# ADDENDUM #1

Reference: Wolverine Services Building Re-roof  
Utah Valley University, Orem, Utah  
Project No. 09080790

# **ADDENDUM NO. 01**

**Re-Roof Project**

**PARAPET CAP DETAIL**  
SCALE: 1/2" = 1'-0"

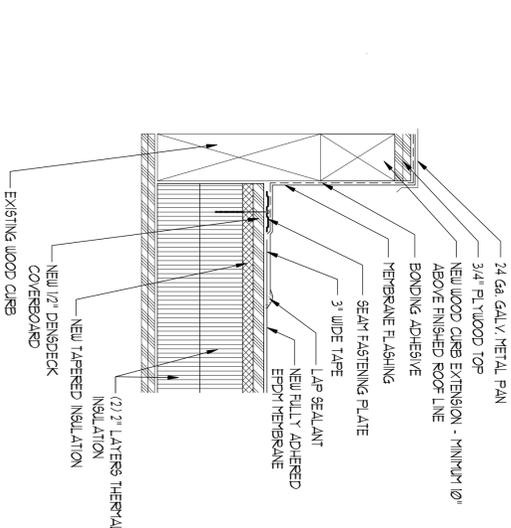
- ITEM 5: Install 2 x 6 studs at 16 inches on center for parapet wall with ½ inch plywood both sides 9 inches tall around the perimeter of all buildings in order to receive tapered crickets. Adjust wall height accordingly for additional insulation if alternate bid is accepted.

**CURB FLASHING @ MECH. UNIT**  
SCALE: N.T.S.

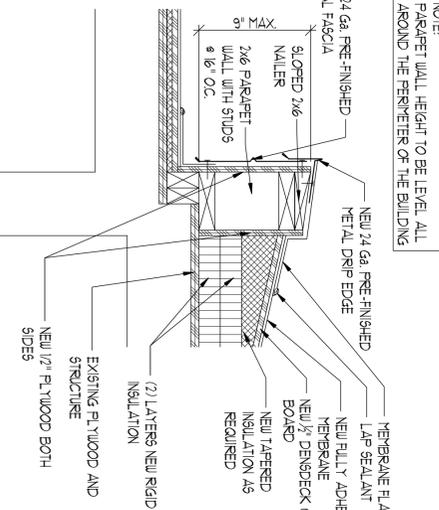
- ITEM 7: Minimum curb heights will be changed from 10 inches to 8 inches.
- ITEM 8: If a “Class A” fire rating can be obtained using a 3” top layer of insulation with a “slurry coated fiberglass facer”, the bottom layers can be 1 inch and 2 inch to achieve the thickness as per the alternate bids for additional insulation.

**COVERED WAY & BARRIER SECTION**  
SCALE: 1/4" = 1'-0"

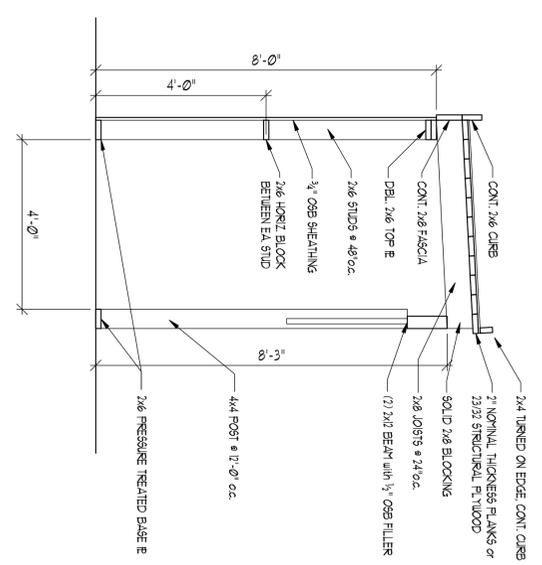
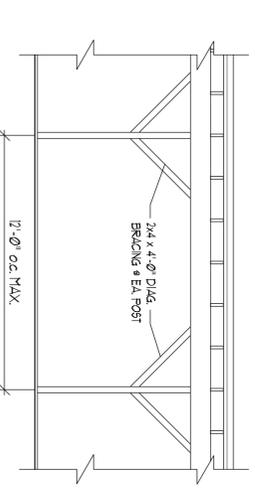
- ITEM 1: Bid opening will not be changed. Bids are due on July 6<sup>th</sup> @ 2:30 PM.
- ITEM 2: Change 4 x 6 posts on temporary framing covers to a 4 x 4 wood post.
